DRAFT
Proposed Update to the
Shoreline Management Plan

April 26, 2024

Smith Mountain Pumped Storage Project FERC No. 2210

Shoreline Management Plan

Figure 1

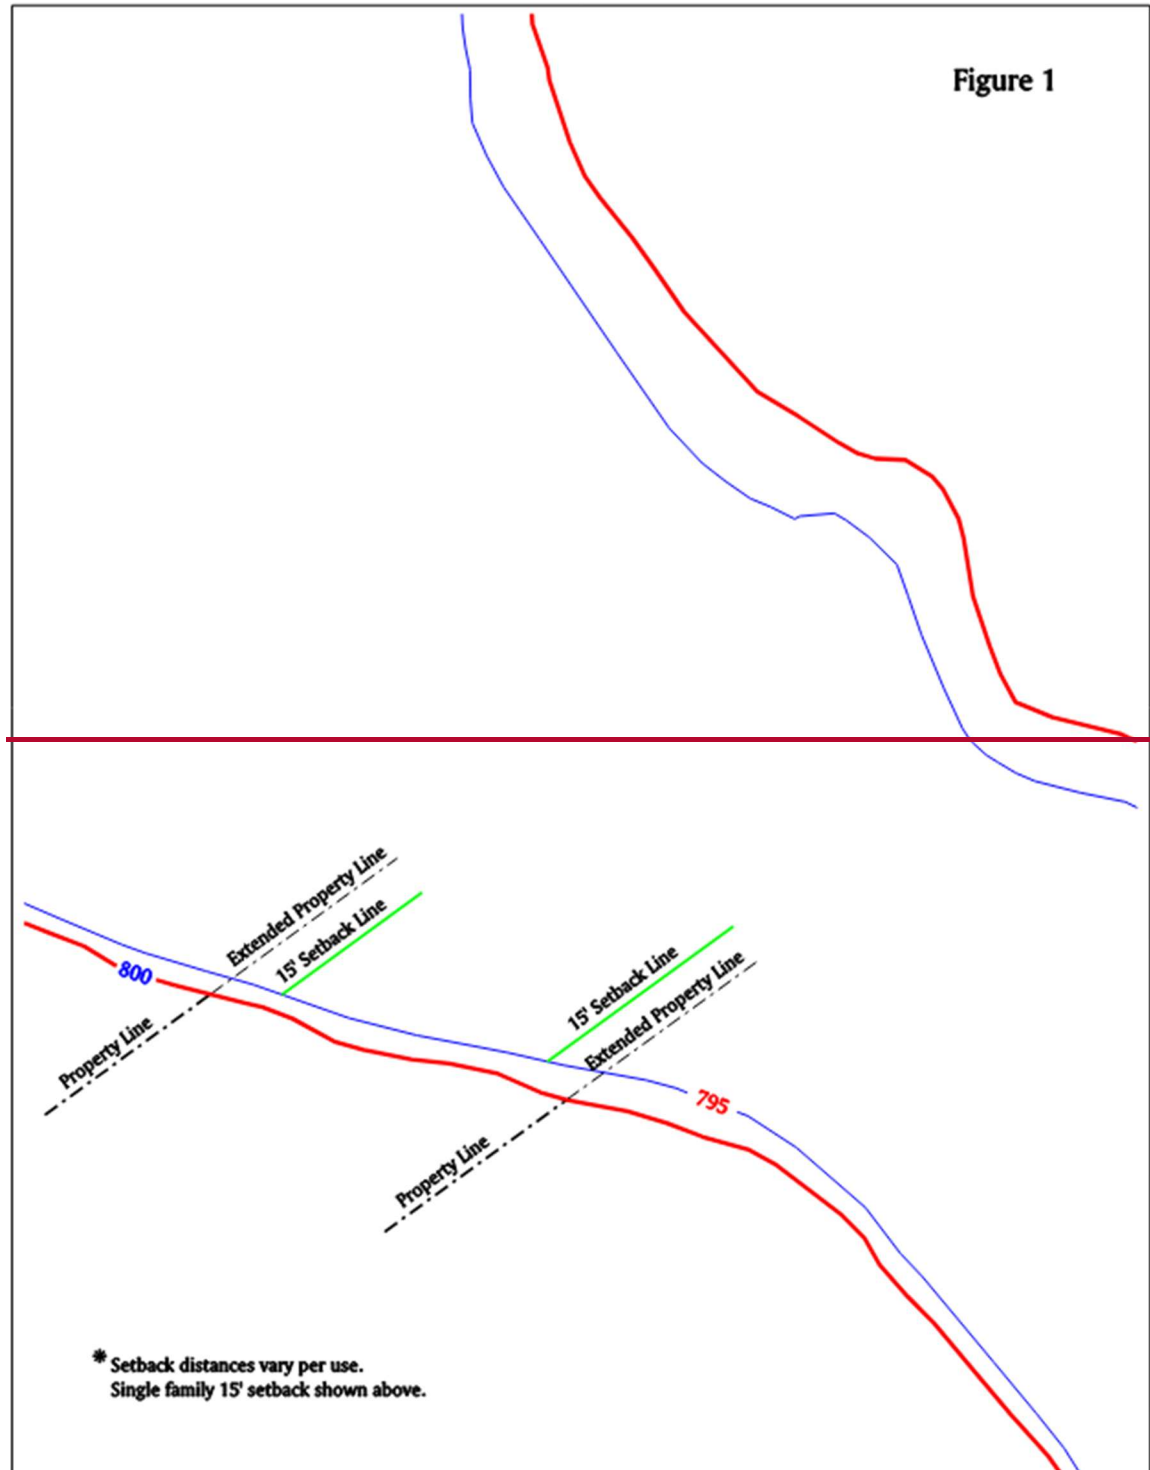
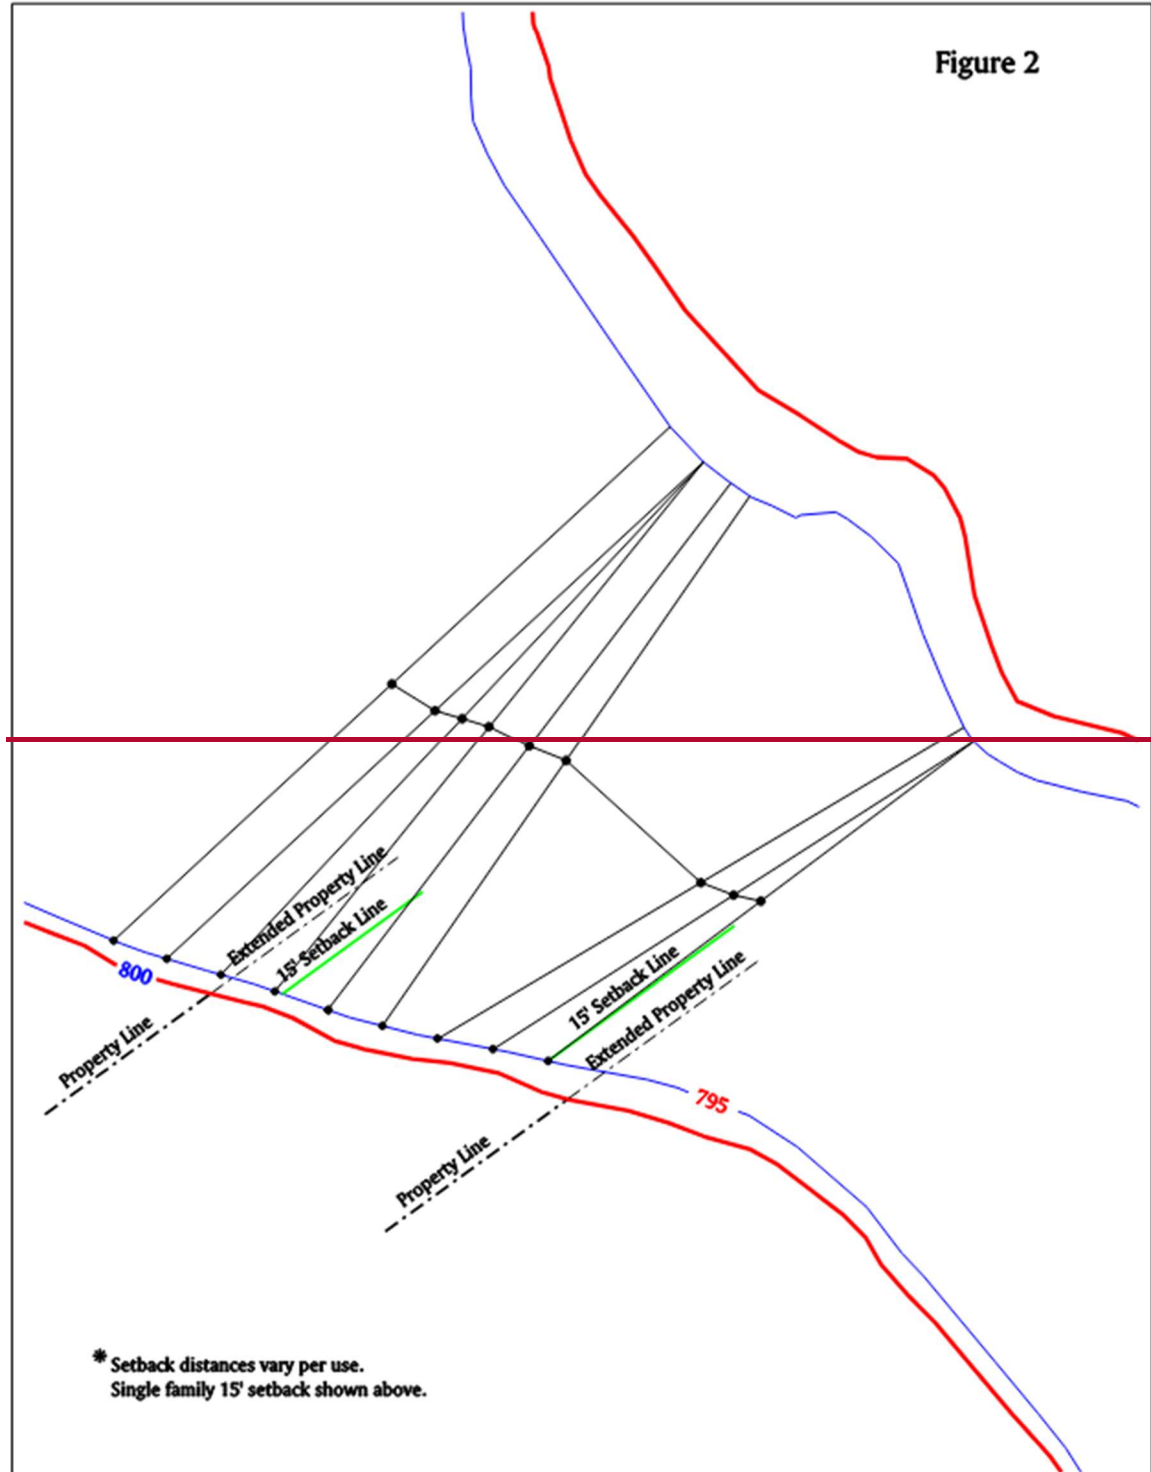
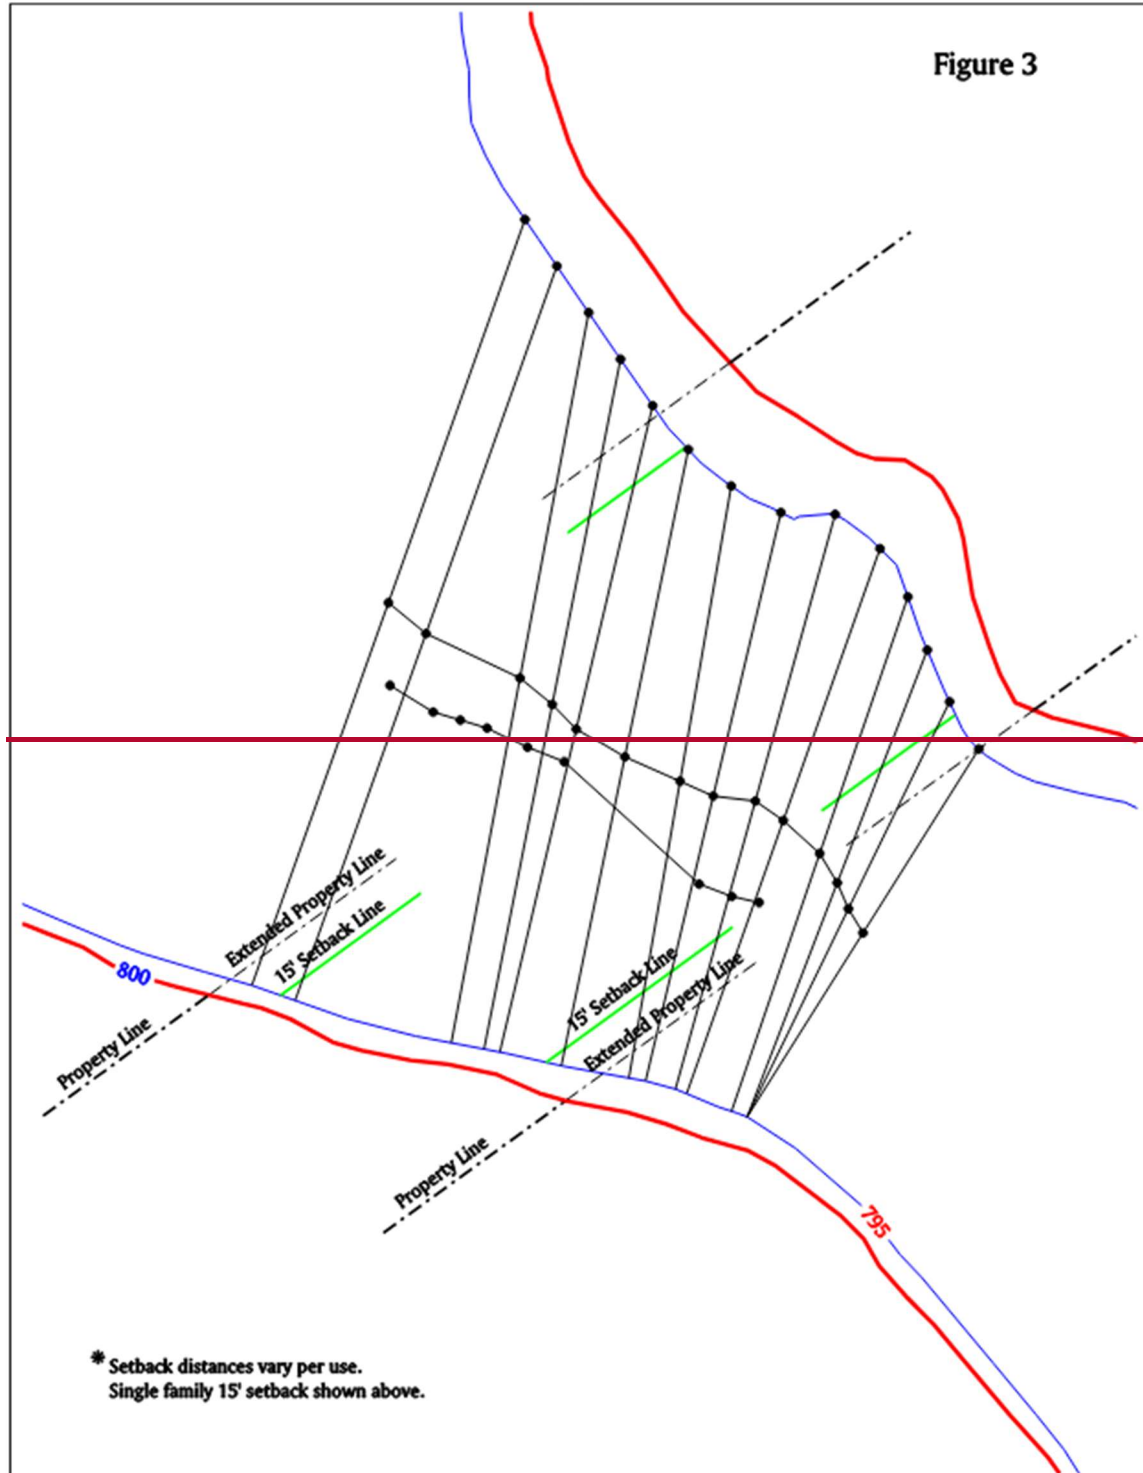
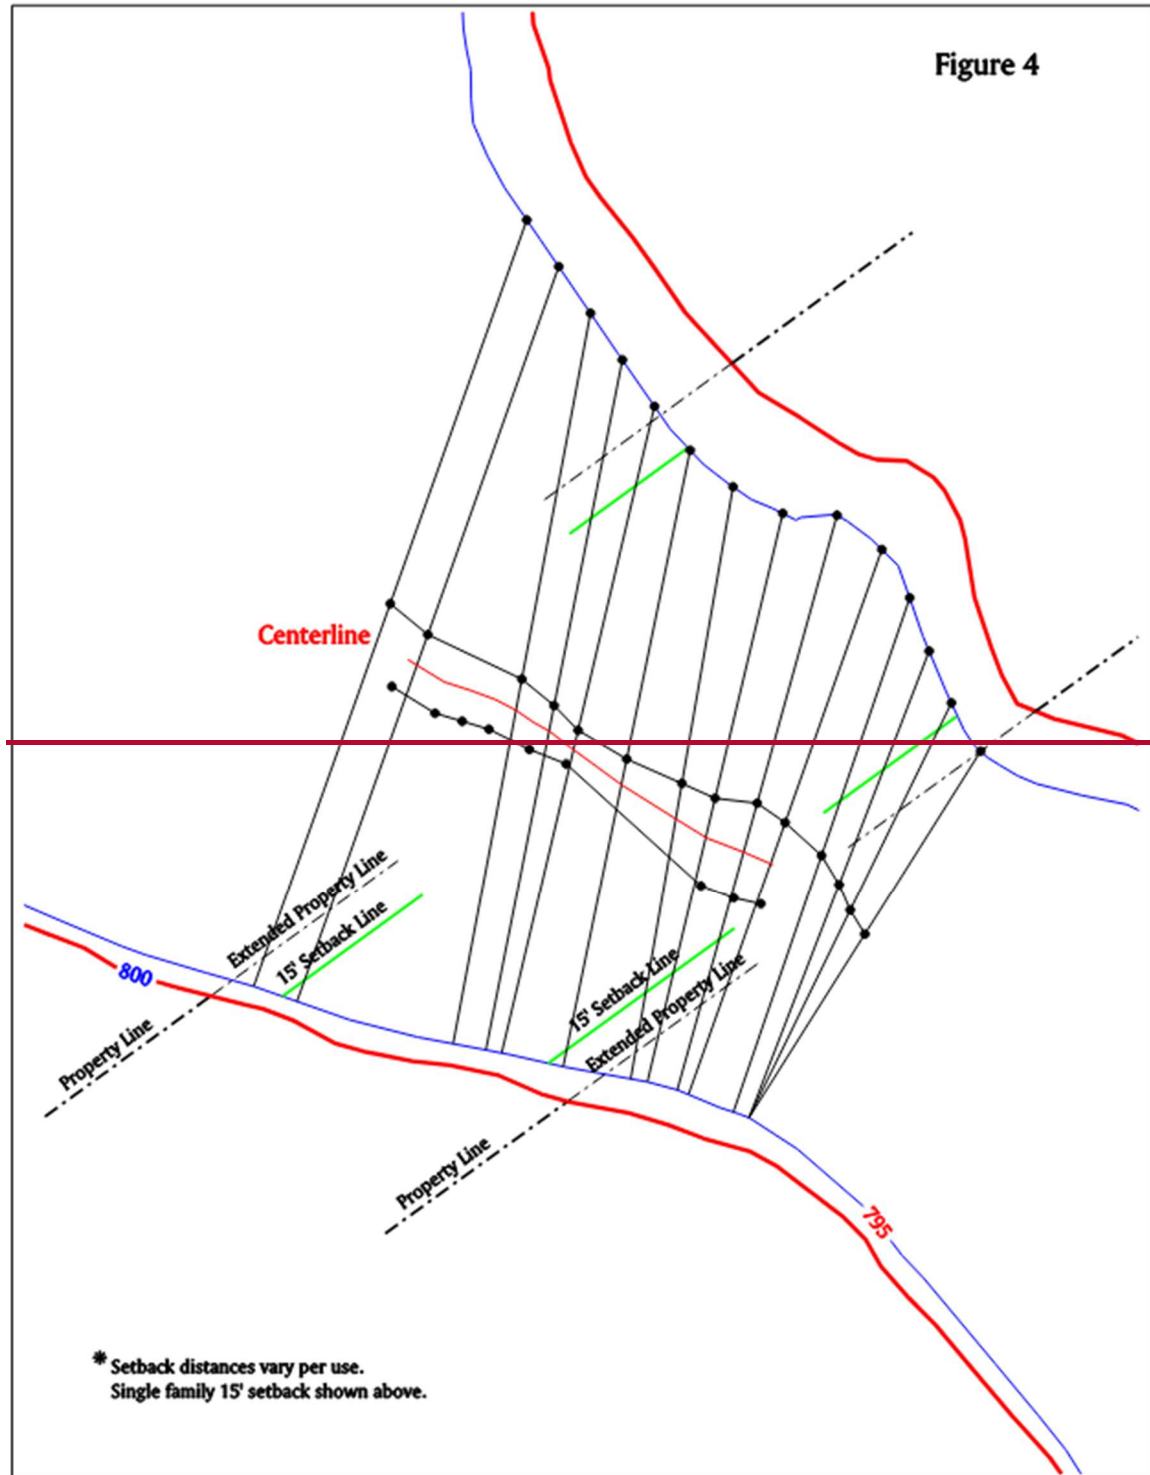
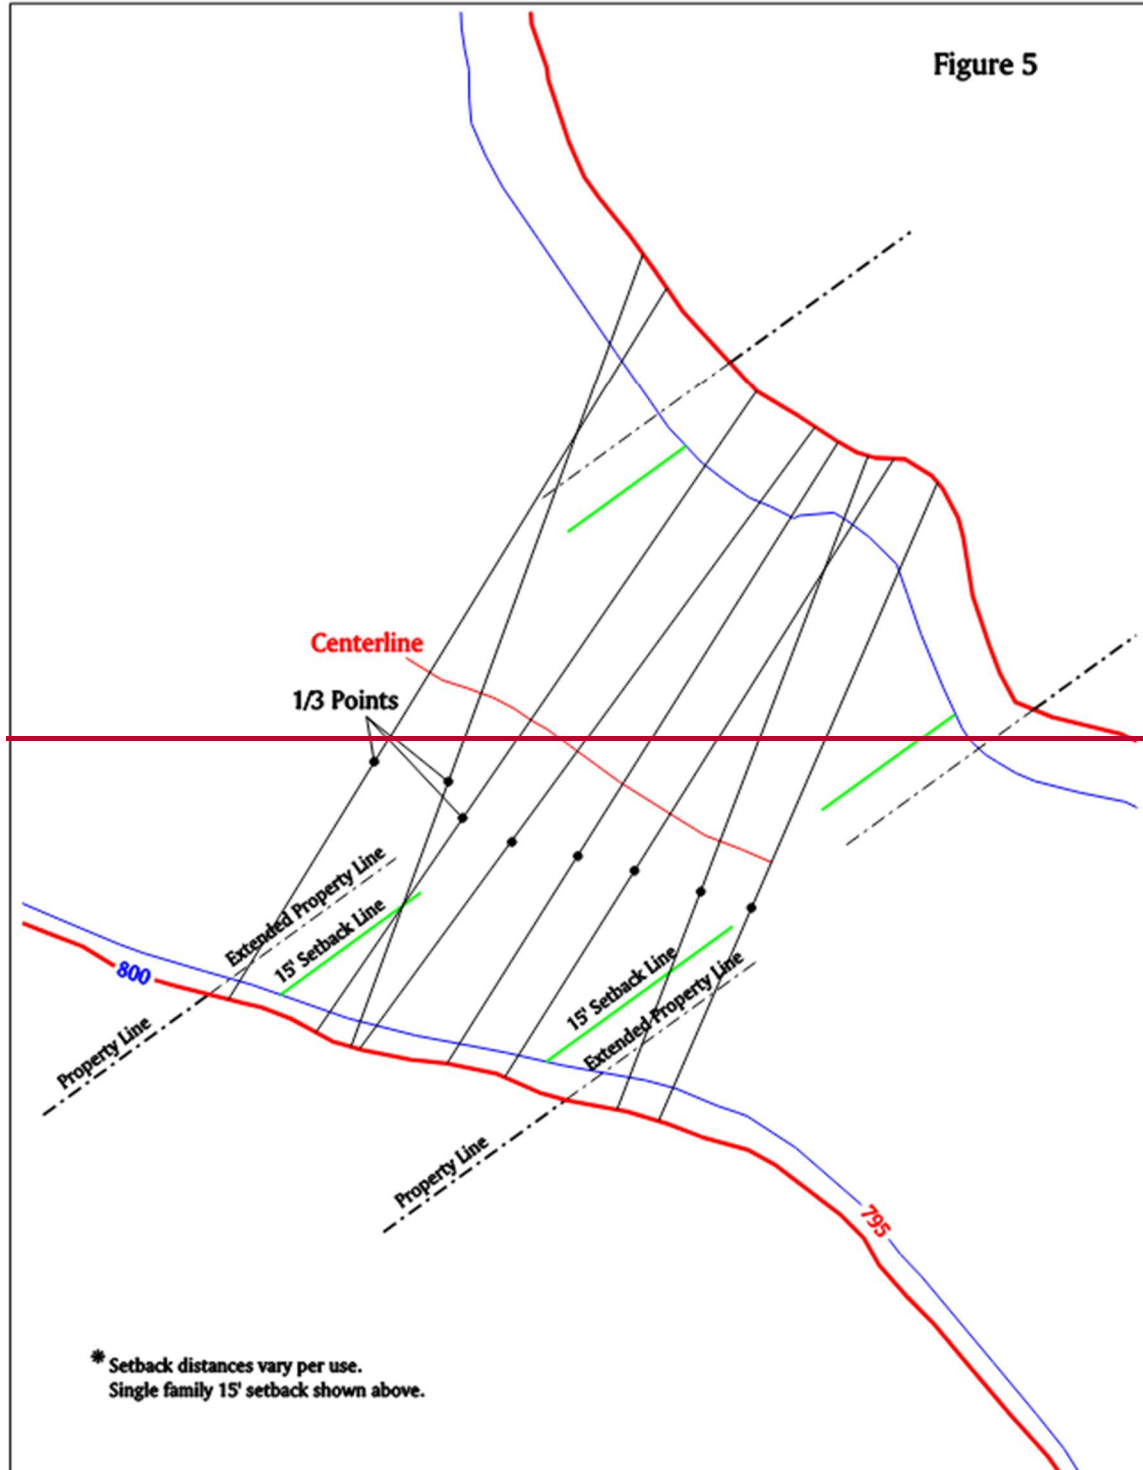
~~b. Step Two – Determination of Closest Points from Shoreline (Figure 2 to Appendix E)~~

e. — Step Three — Determination of Closest Points from Opposite Shoreline (Figure 3 to Appendix E)

Step Four — Determination of Waterway Centerline (Figure 4 to Appendix E)

b. Step Two – Determination of Waterway Centerline (Figure 2 to Appendix E)

To demonstrate the accuracy of the centerline, Appalachian may require additional information as depicted in Figure 2A of Appendix E. If required by Appalachian, extend the subject property's dock delineation lines (or extended property lines) to the centerline of the waterway. At each point where the dock delineation line (or extended property line) intersects the centerline, draw a circle with the shortest possible radius so that the circle is tangent to the base elevation on both sides of the cove. If the circle is not tangent to the base elevation on both sides of the cove, the centerline may be incorrect.
